**GEOTECHNICAL AND GEOLOGIC HAZARD INVESTIGATION**  
**The Ridge Nests Development**  
**Powder Mountain Resort**  
**Weber and Cache Counties, Utah**

IGES Project No. 01628-008

July 15, 2016

Subject: Response to Review Comments  
Geotechnical Investigation  
The Ridge Nests Development  
Powder Mountain Resort  
Weber and Cache Counties, Utah

C:\DOCUME~1\DAVIDG\DESKTOP\01628008\B1.PL2 Run By: DAG 9/1/2015 2:04PM

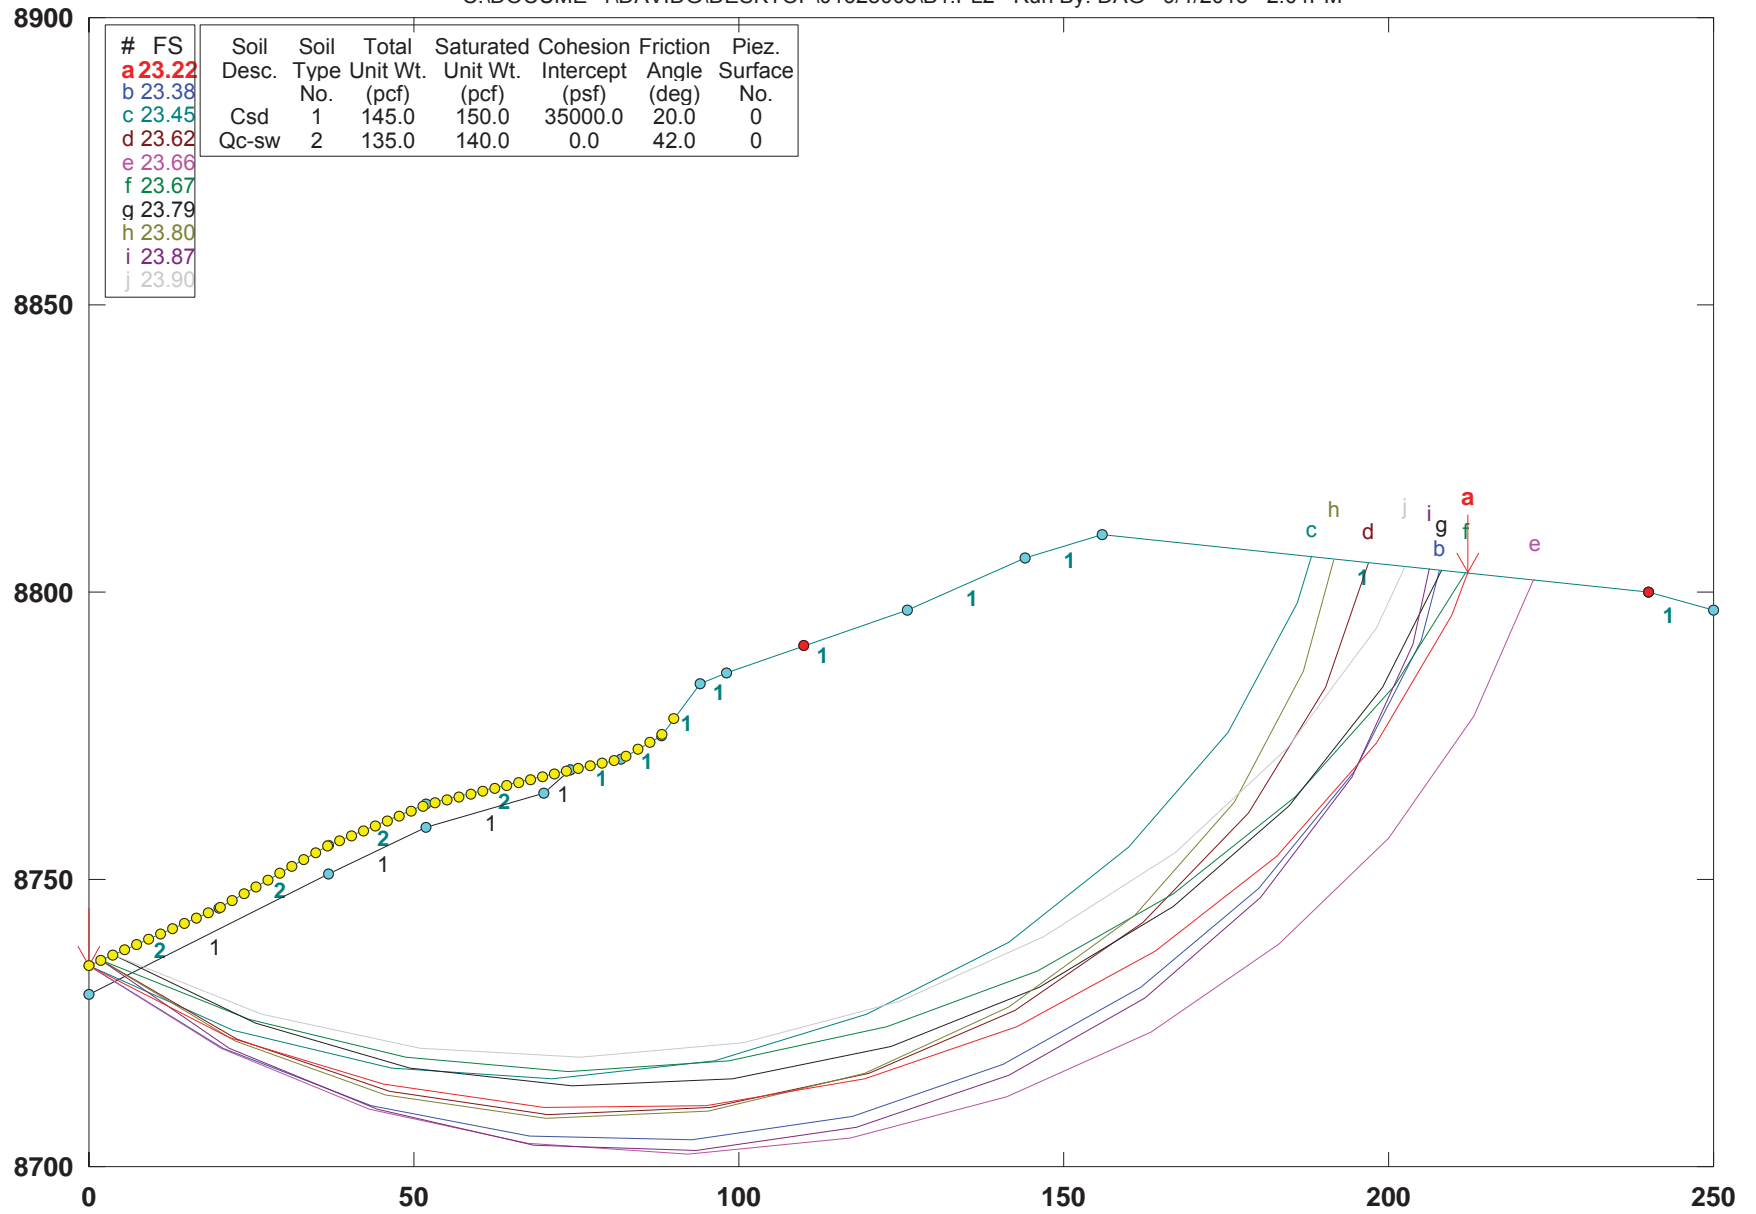
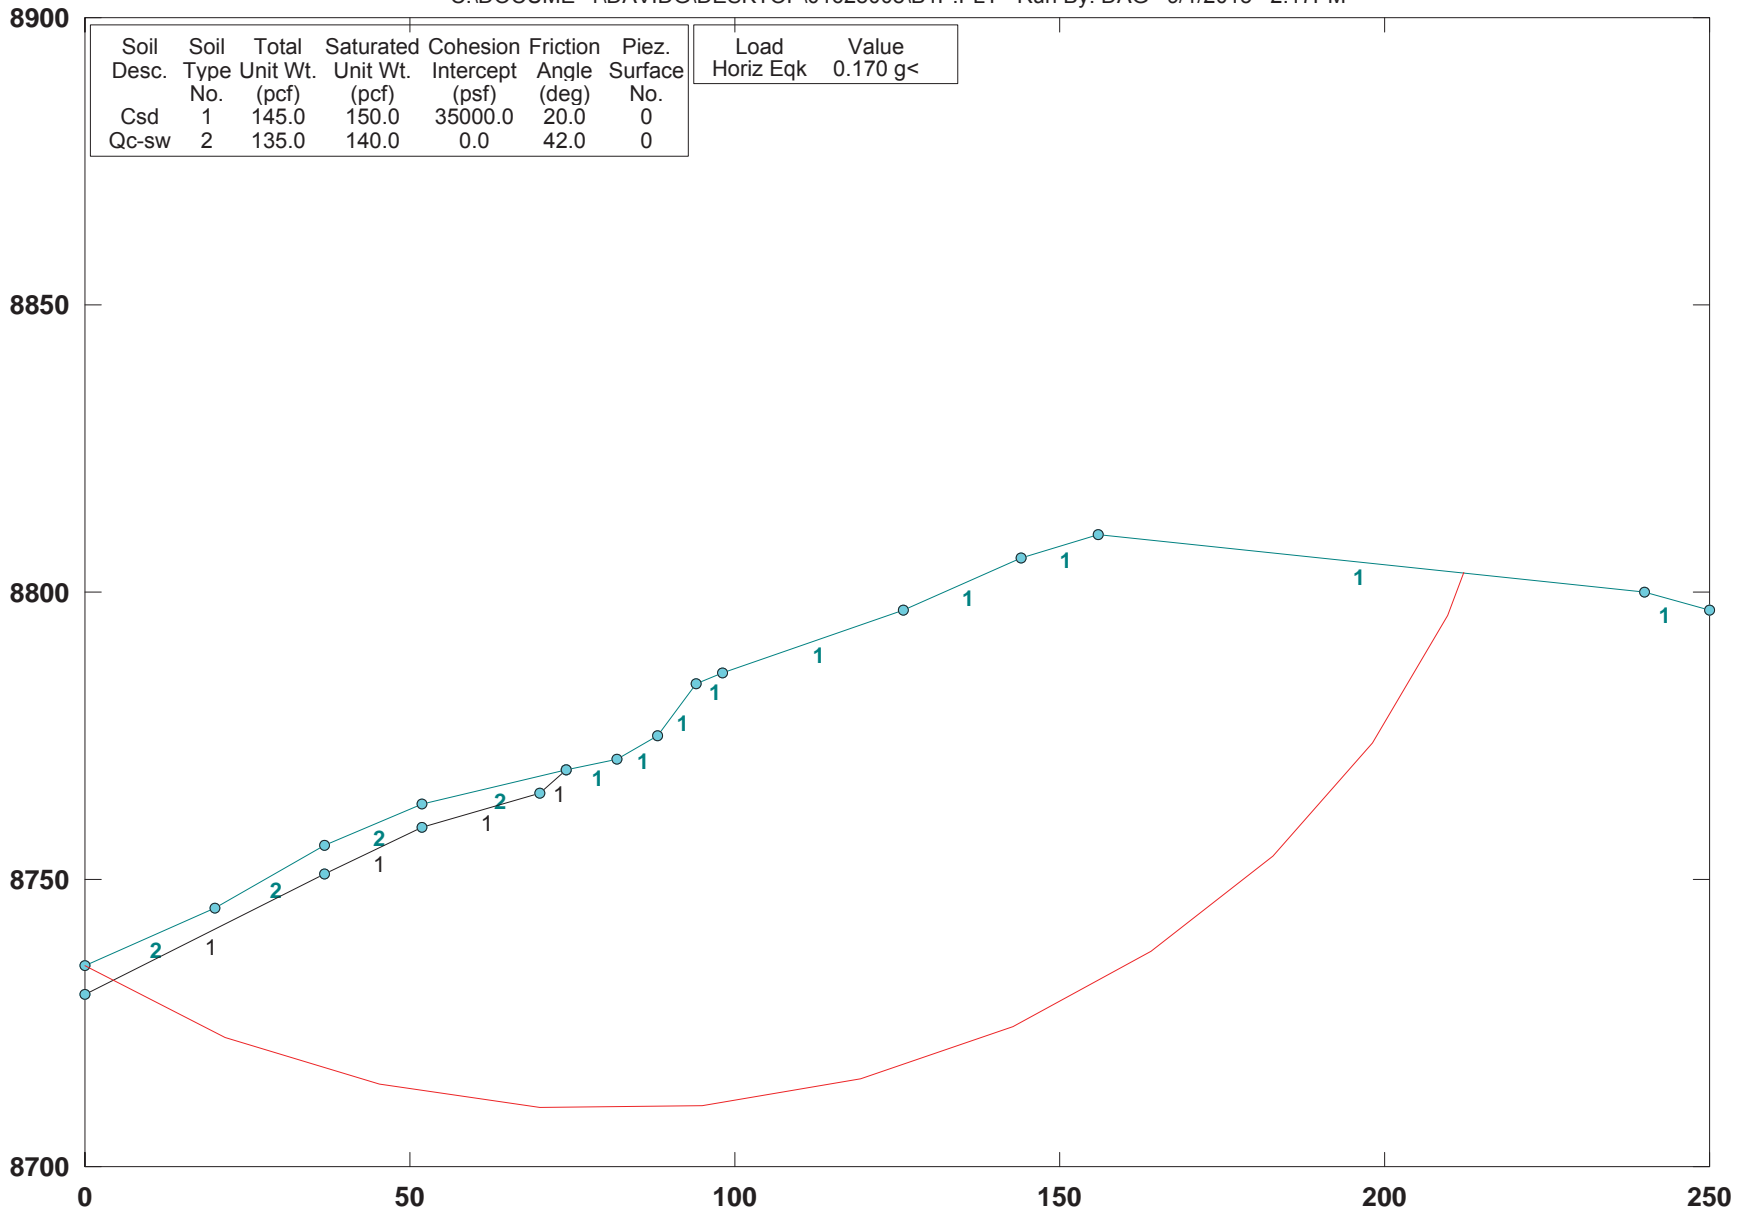
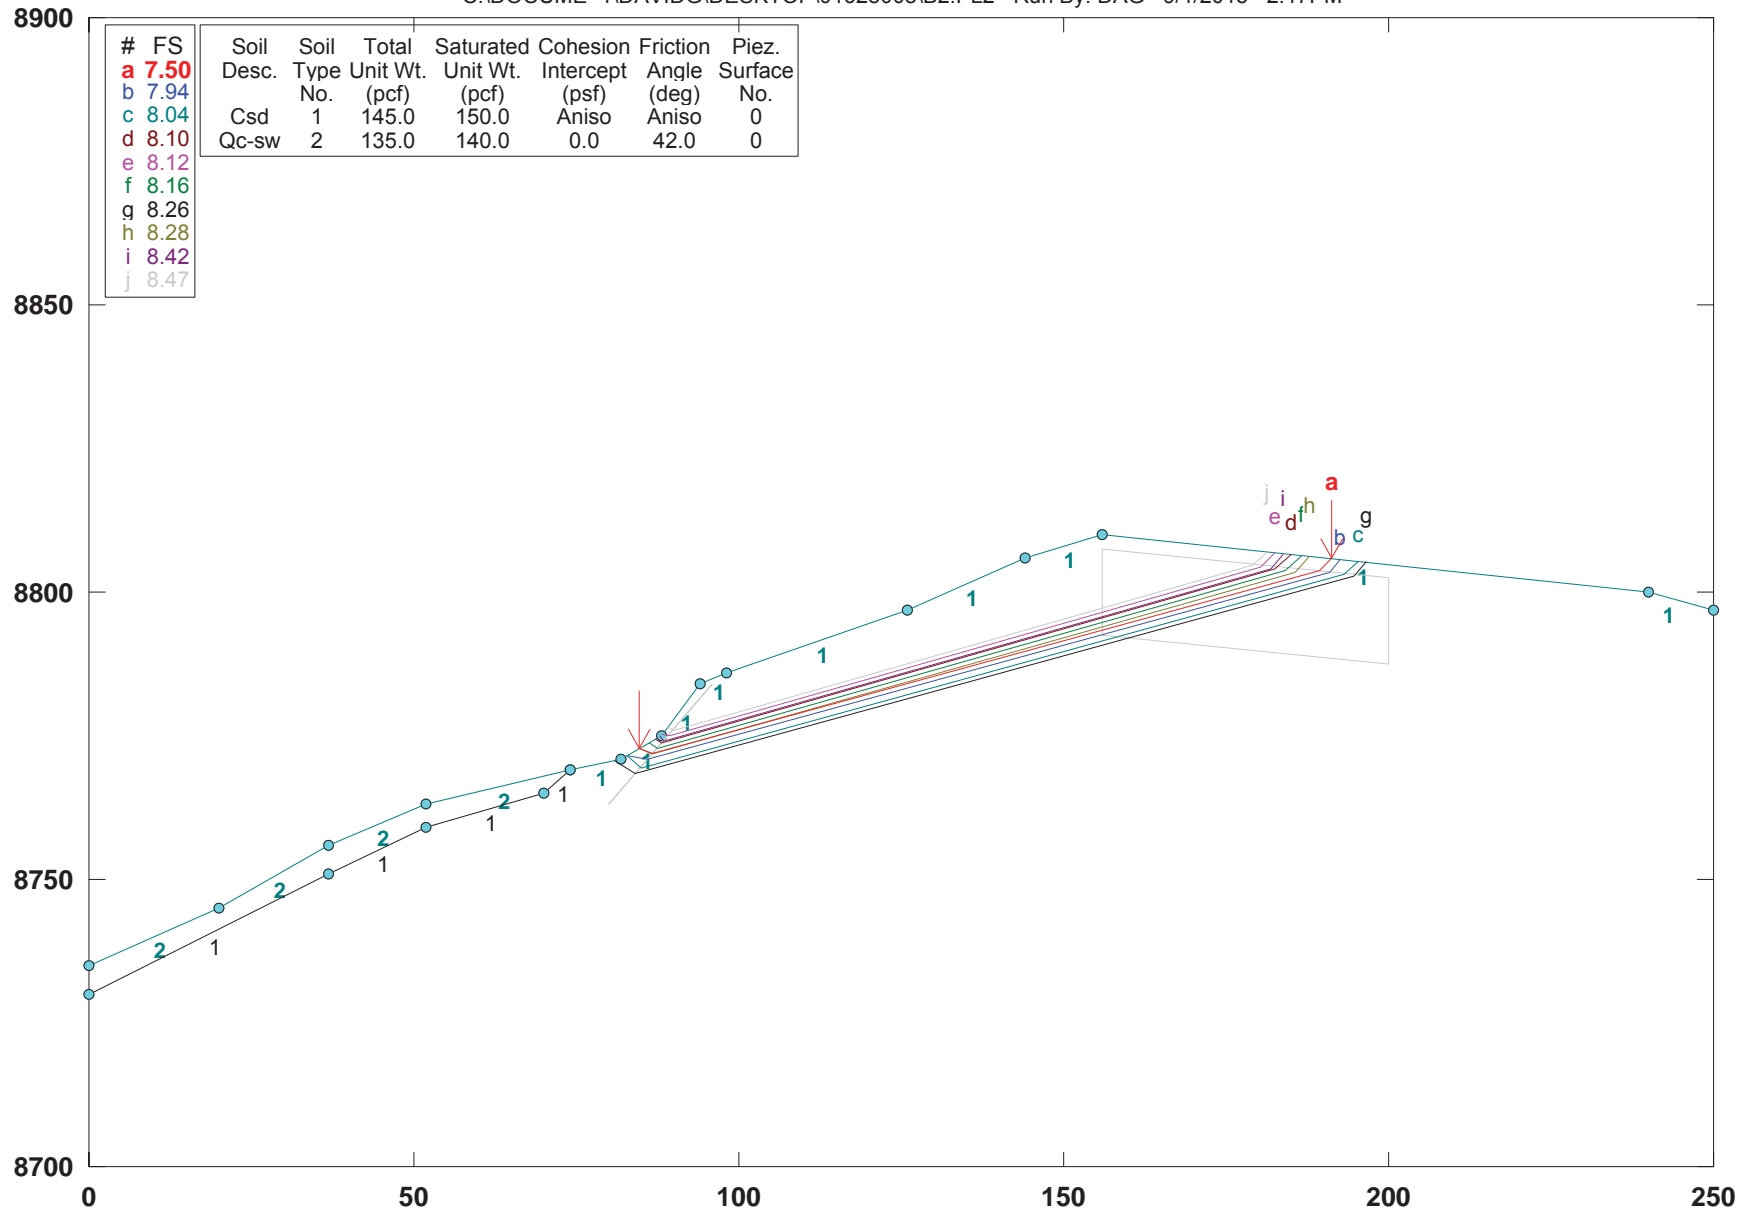
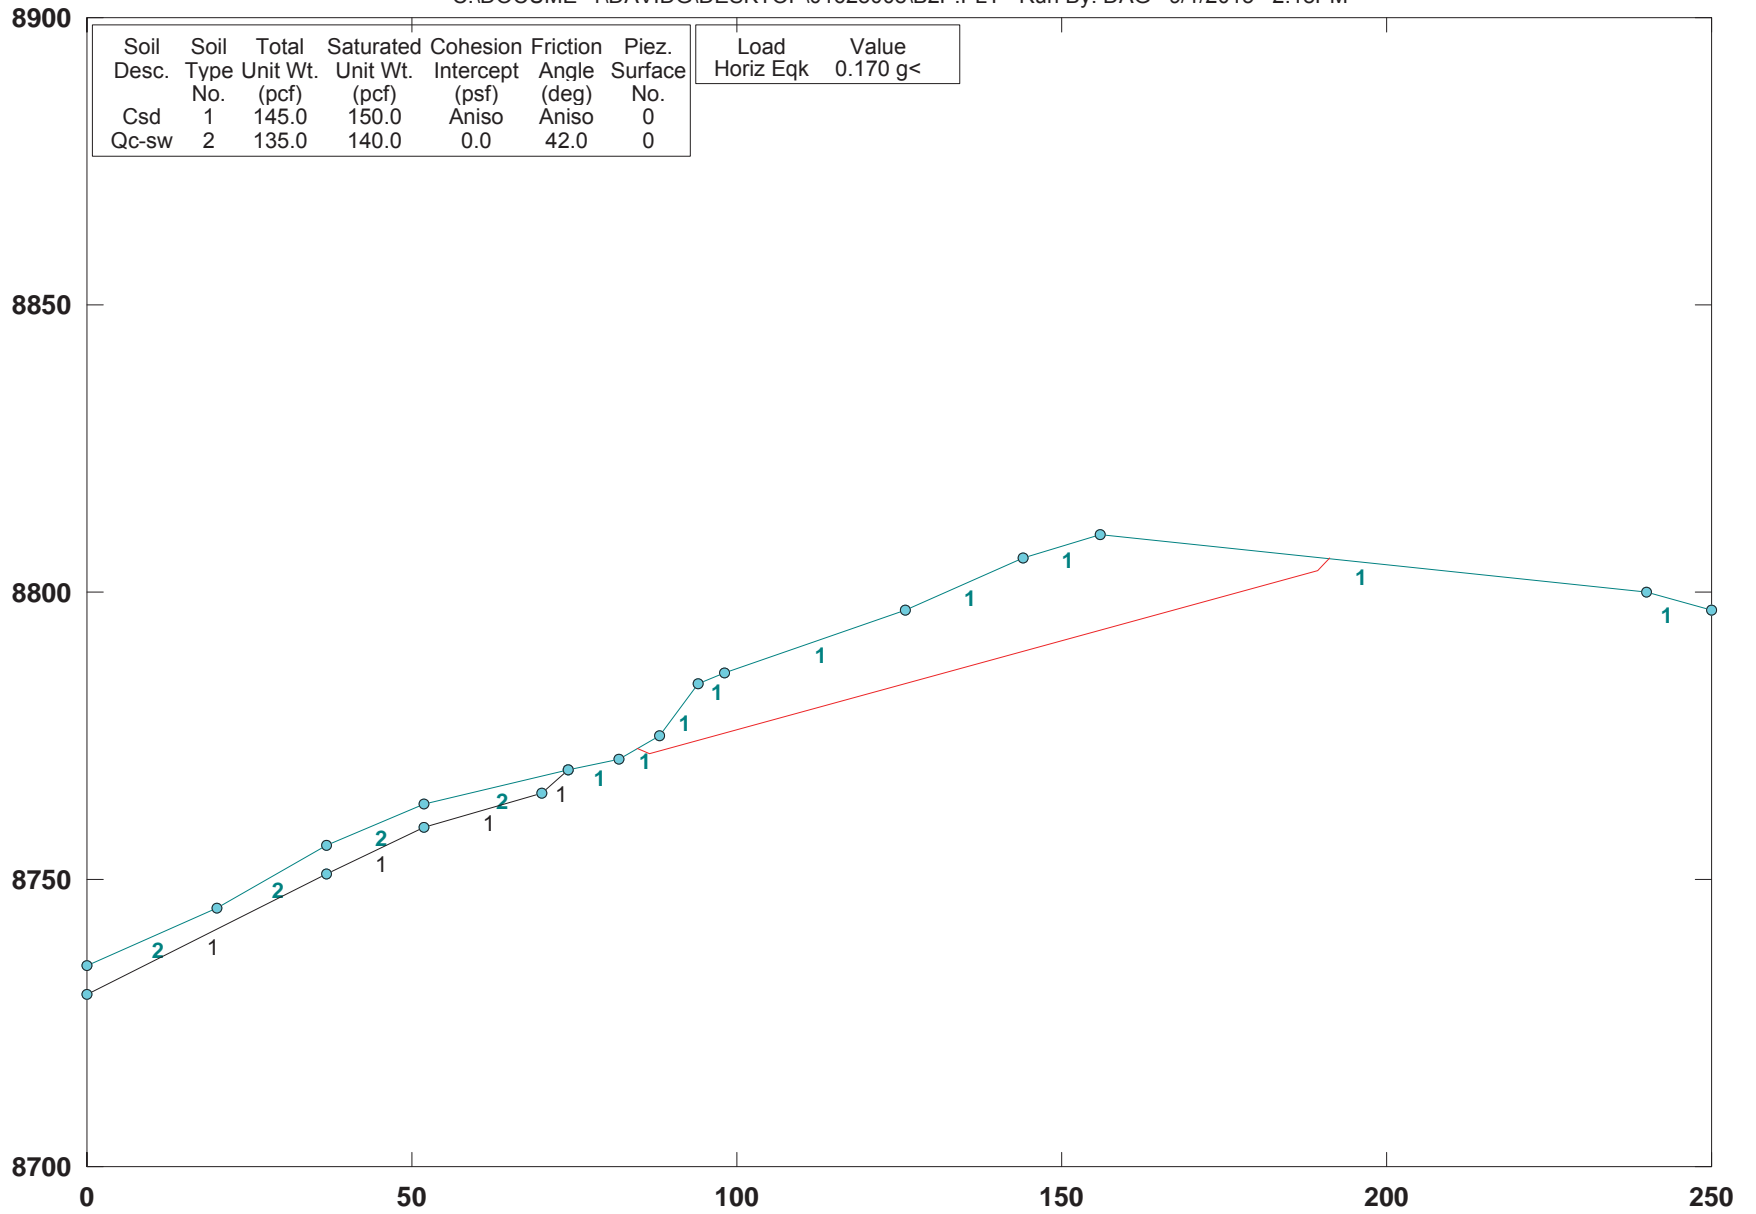
#### **Comment No. 1**

The global stability of the slope was modeled using gSTABL7 slope stability software. Bishop’s Method and Janbu’s Simplified method was used to model the slope, as appropriate. For our analysis, we have assessed two representative sections, Section A-A’ and Section B-B’, illustrated on Plate 1 (*Geologic Map*) and the *Geologic Cross-Sections*, Figure 1, attached. Calculations for stability were developed by searching for the minimum factor-of-safety for both a circular-type failure and a block-type (translational) failure. For the circular analysis model, arcuate failure surfaces and homogenous earth materials were assumed. For the block analysis, anisotropic strength parameters in the bedrock was assumed, based on the apparent dip of bedding. A minimum static factor-of-safety of 1.5 and seismic factor-of-safety of 1.0 (global stability) was considered acceptable for this project considering the available information and design assumptions.

**Photo 1. Finer-grained dolomite lithology, exhibiting thinner beds and blocky jointing.**

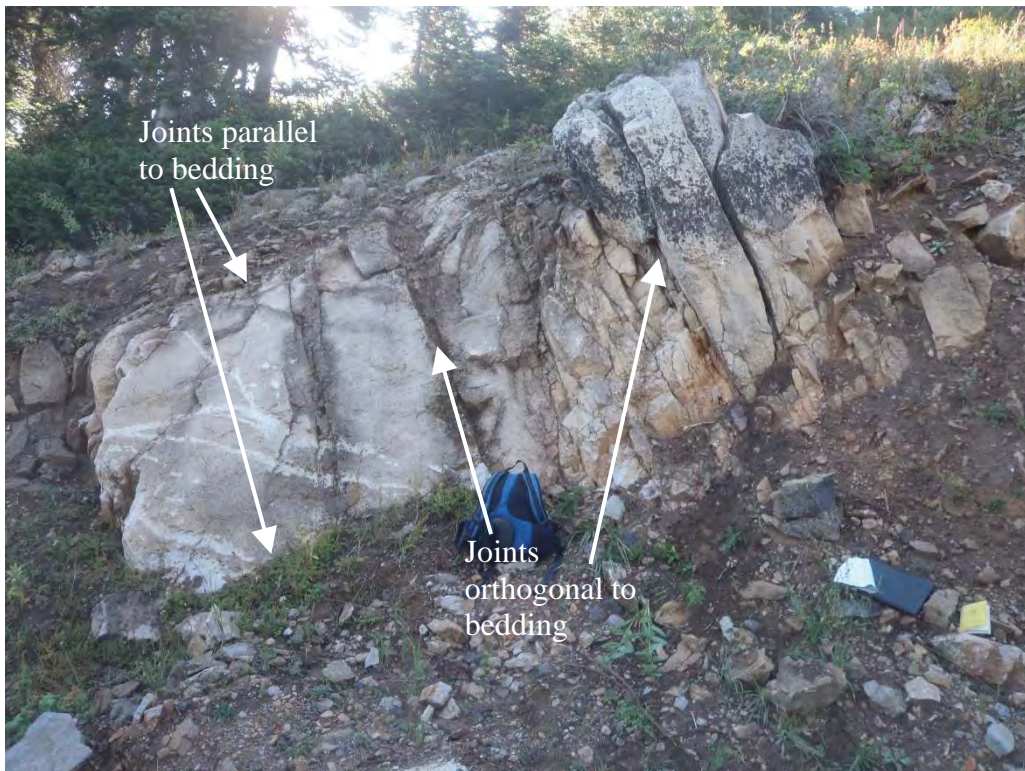
**Comment No. 1**

*“The September 23, 2015, IGES response letter did not describe the properties of the bedding and/or jointing for incorporation into the slope stability analyses, e.g., properties such as, strike and dip, degree of fracturing (generally controlled by the number of joints in a given direction), persistence of jointing, spacing of jointing, roughness of joint surface, open and/or closed joints, joint coatings and infillings, etc.*

IGES did describe the strike and dip of the bedding and jointing in the September 23, 2015 response letter; IGES noted bedding near the subject site was oriented (strike) about N24°W and dip (inclination from the horizontal) at 25°NE. The bedrock was found to have blocky jointing, with the two major sets being orthogonal to one another. One joint set was parallel to the bedding, and the other was perpendicular to the bedding, dipping steeply to the southwest. The joint set parallel to the bedding has the same strike and dip orientation as the bedding, while the other major joint set perpendicular to the first has a strike of approximately N24°W and a dip of approximately 65°SW.

In response to the comment, the following additional details are provided: bedrock was found to be largely moderately fractured (distance between fractures ~0.5-1.0 feet) to little fractured (distance between fractures ~1.0-4.0 feet), with localized areas of intense fracturing (distance between fractures ~0.05-0.1 feet). Joint spacing was largely found to be a product of the lithology. The finer-grained dolomite lithologies were more thinly bedded, and therefore had a smaller distance (approximately 1 to 4 inches) between bedding plane joints. These lithologies also tended to fracture into rectangular blocks generally between 4 and 18 inches in length and width, and contained both bedding-confined and through-going fractures (Photo 1). Coarser-grained dolomite lithologies were more thickly bedded to massive, with bedding plane joints separated by between 6 inches to as much as several feet. These lithologies tended to fracture into rectangular blocks with highly variable dimensions, ranging in width and length from between a couple inches to several feet, though larger blocks (with dimensions of several feet x several feet x several feet) were most common (Photo 2). Most fracturing associated with the coarser-grained dolomite lithologies consisted of large through-going fractures.

Nearly all of the joints encountered in the field investigation were open, had slightly rough to rough surfaces, and did not contain a secondary mineralization, except rare calcite infilling in places. No slickensides were observed on any joint surface. Joint apertures varied from between a few millimeters to a couple inches in width. Joints with smaller apertures tended to be devoid of any sort of fill, while the larger aperture joints were often filled with soil. In the cases of the two identified faults, reddish gray silty gouge was found to be the fill material.
